RE: 56 MGD Upgrade Project T.Z. Osborne – Package 2
Effluent Filter – Effluent Facilities

As a follow up to various onsite meetings and discussions, Garney offers the following quotation for the construction of the Chlorine Contact Splitter Box, Filter Effluent Structure, and interconnecting piping.

ADVANCING WATER	TZ OSBORNE PACKAGE 3			
	EFFLUENT FILTER STRUCTURE			
	10/19/2015	SIZE	FSCM NO.	DWG NO. TZ03-A
SCALE NTS		SHEET

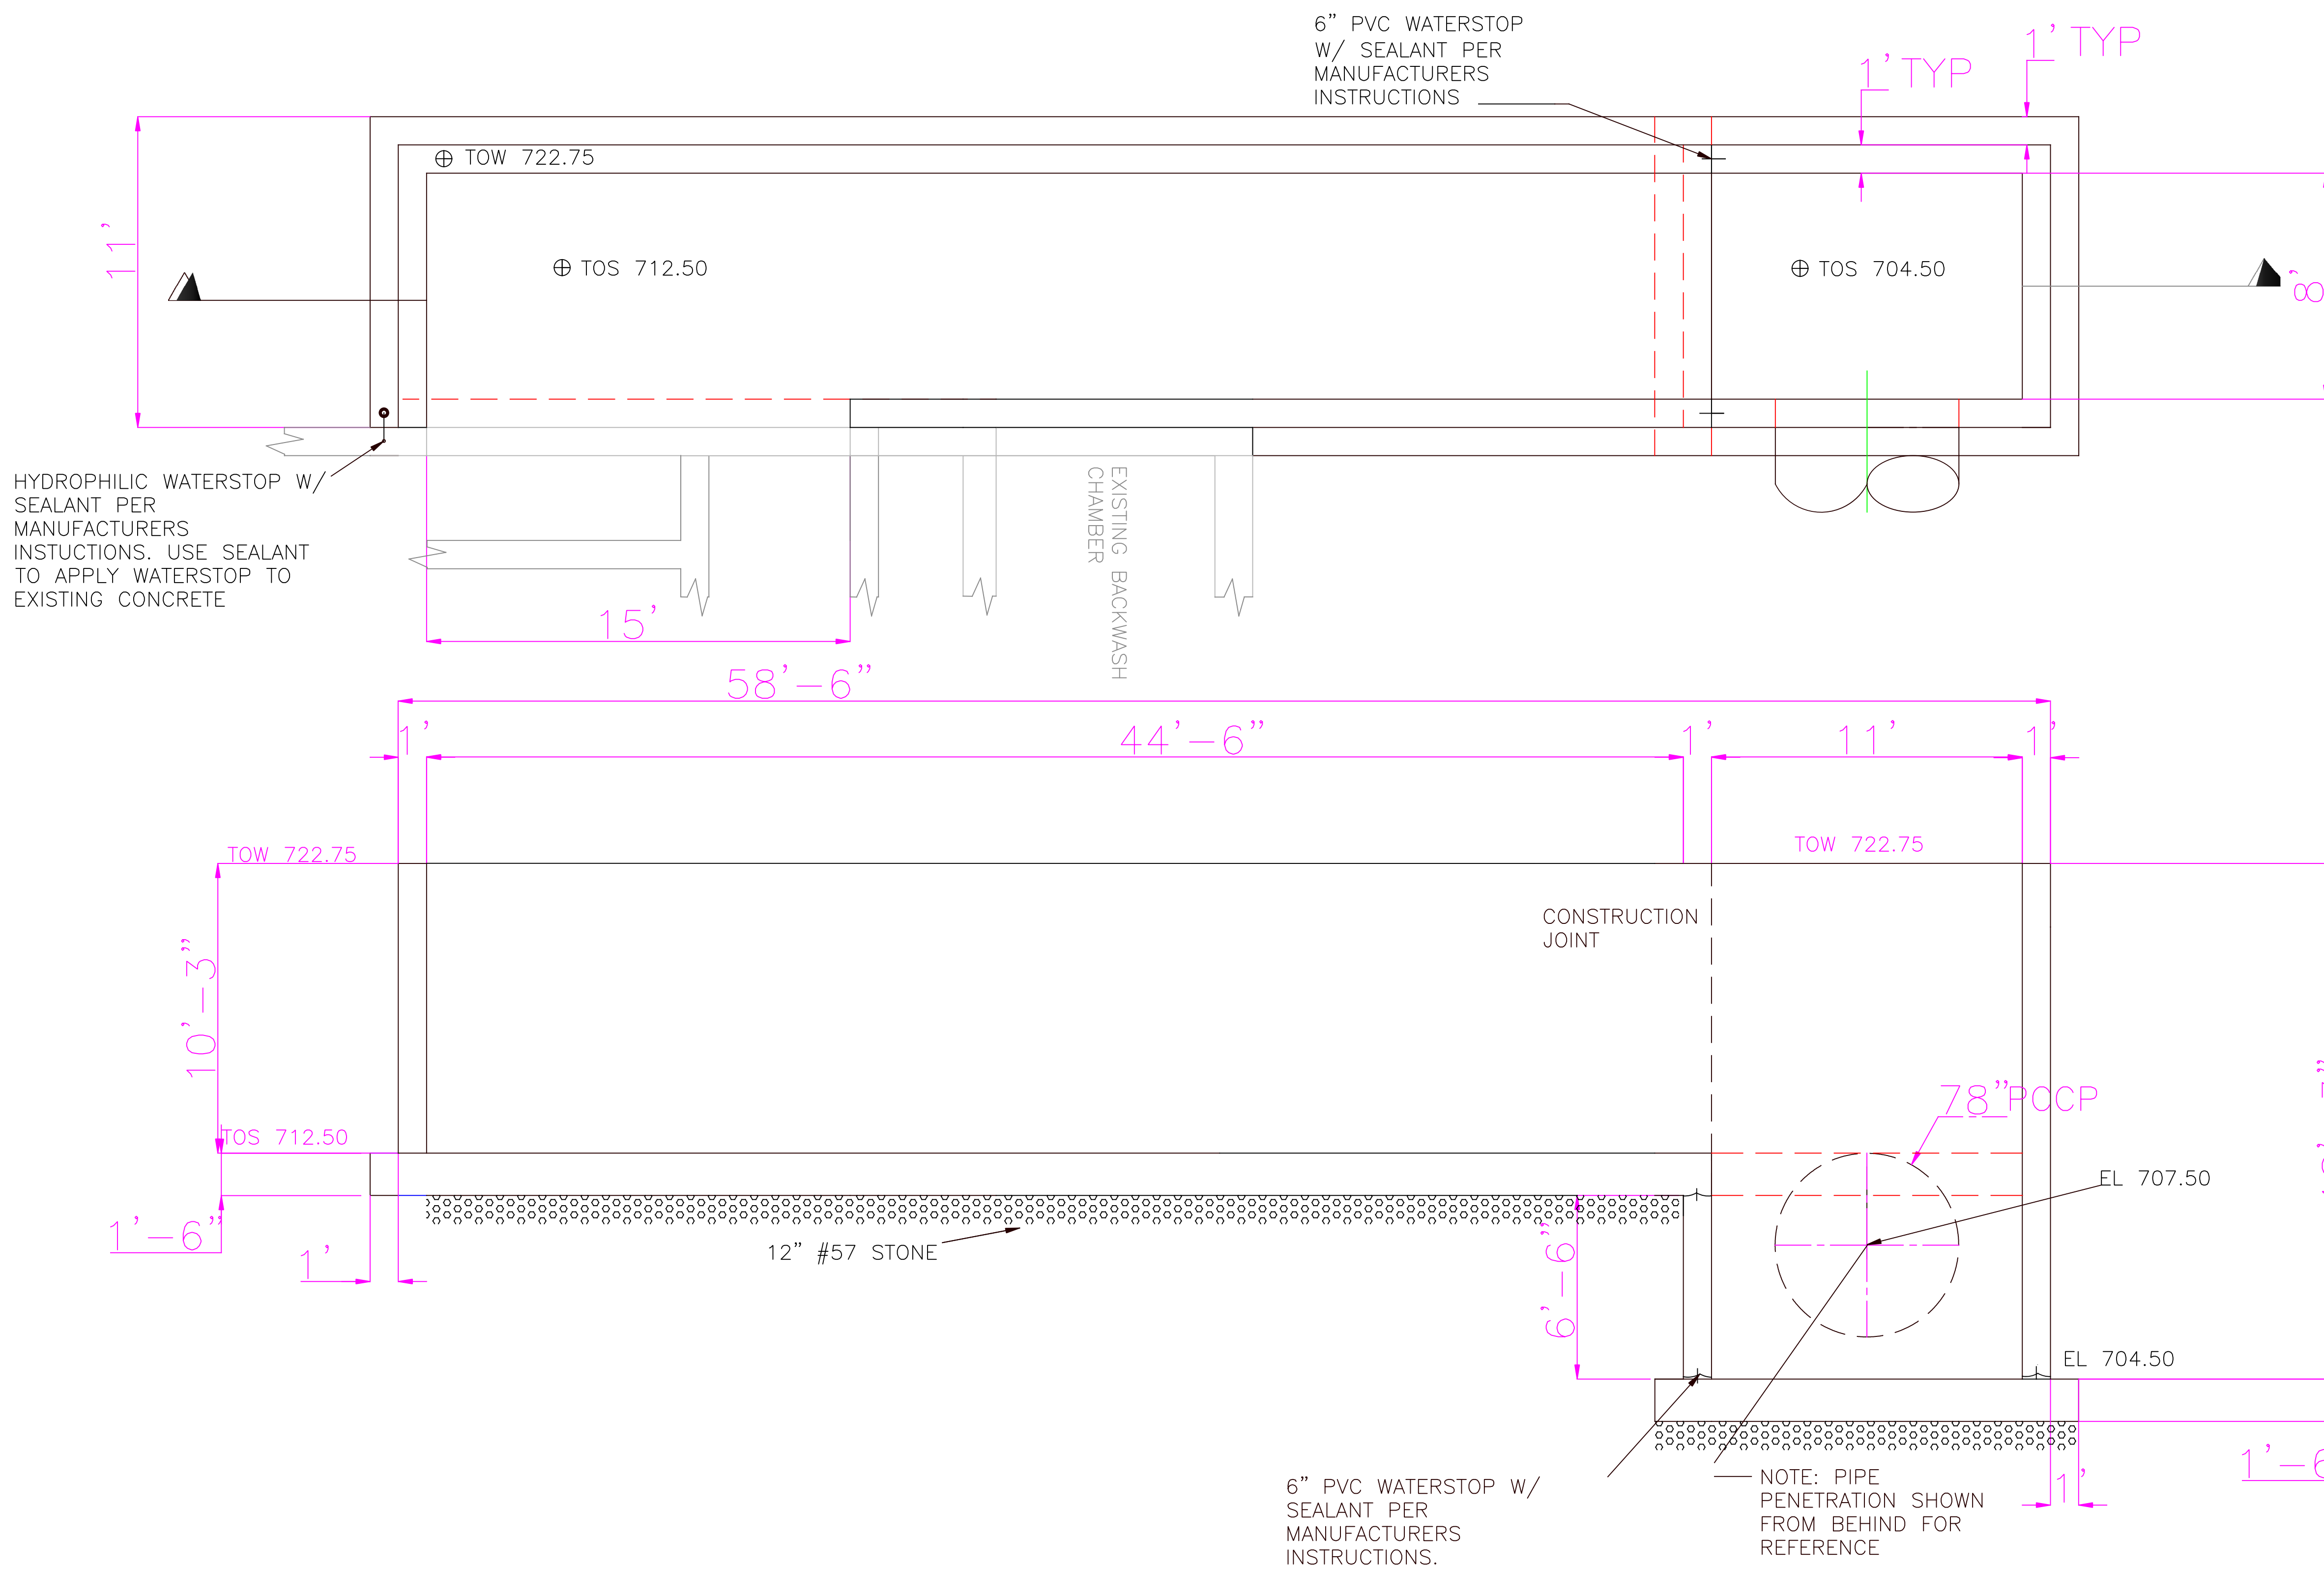
4. Filter Effluent Structure
 - a. Size, shape and elevations as indicated on attached sketch titled TZO3-A, dated October 19, 2015
 - b. 12 Tons of reinforcing steel

- c. 124 rebar dowels to be drilled and epoxied into the existing filter structure
 - d. Walls no more than 12-inches thick
 - e. Slabs no more than 18-inches thick

- f. One 78-inch wall PCCP wall pipe connection to Filter Effluent Pipeline, at Centerline Elevation 707.5 ft
 - g. 12-inches of crushed concrete / stone base below slab

TZO3-B

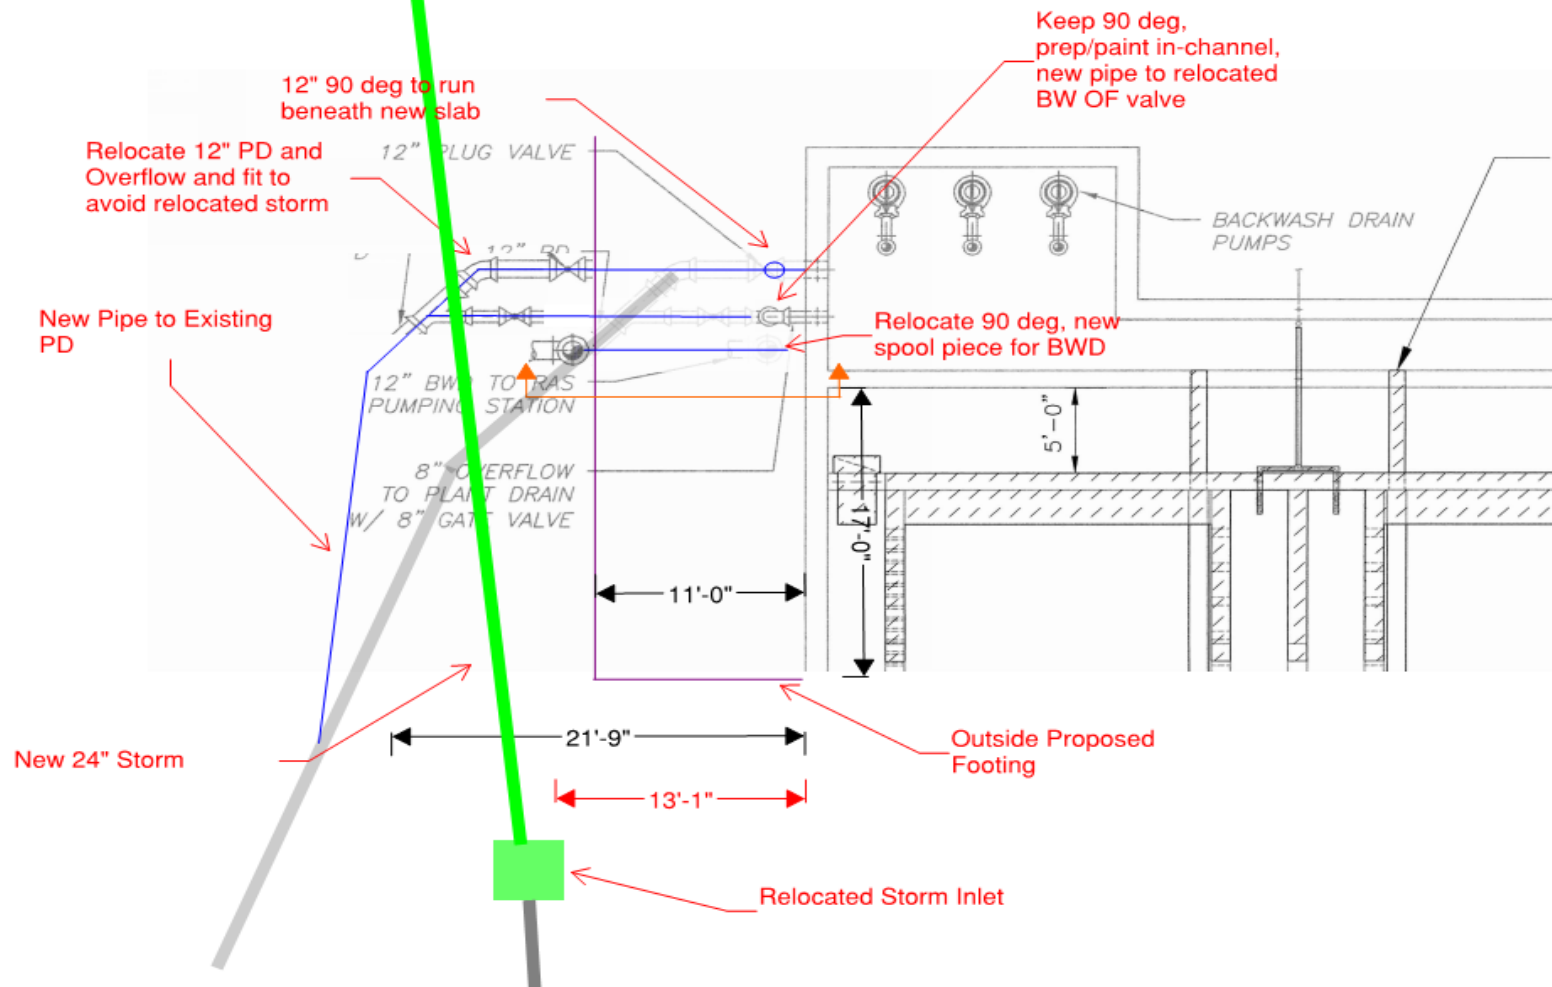
3. Relocation of effluent filter backwash drain, and overflow, and pump discharge piping near the North East corner of Effluent Filter, as shown on attached plan view sketch titled TZO3-B, dated October 19, 2015 as well as section view shown on sketch TZO3-C dated October 19, 2015. Garney will require an expected two shut downs of 6 hrs. each, of the filter backwash system in order to complete relocation of PD, OF, and BWD lines as indicated.

TZO3-D

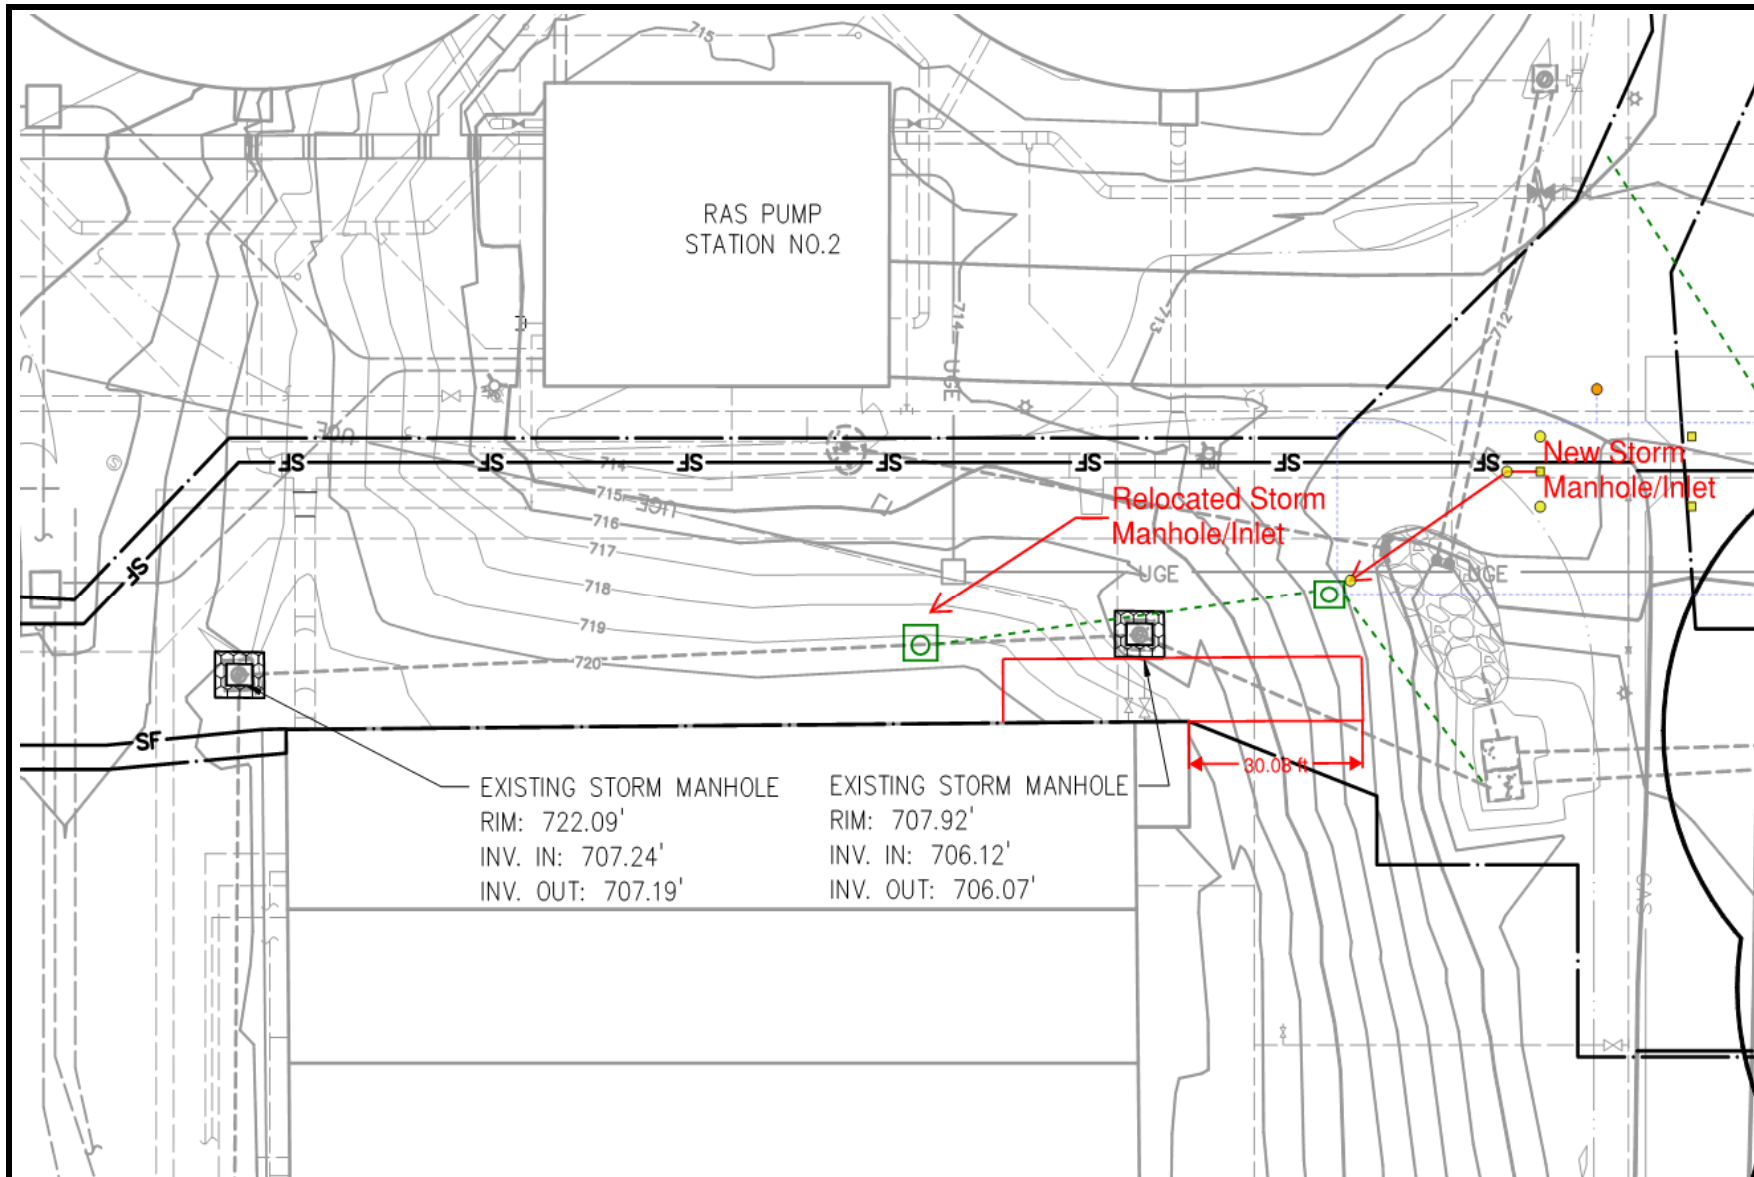
1. Excavation, backfill, groundwater dewatering
2. Relocation of storm inlet box, and re-alignment of storm drain piping including new storm transition manhole near the North East corner of Effluent Filter, as shown on attached sketch titled TZO3-D, dated October 19, 2015
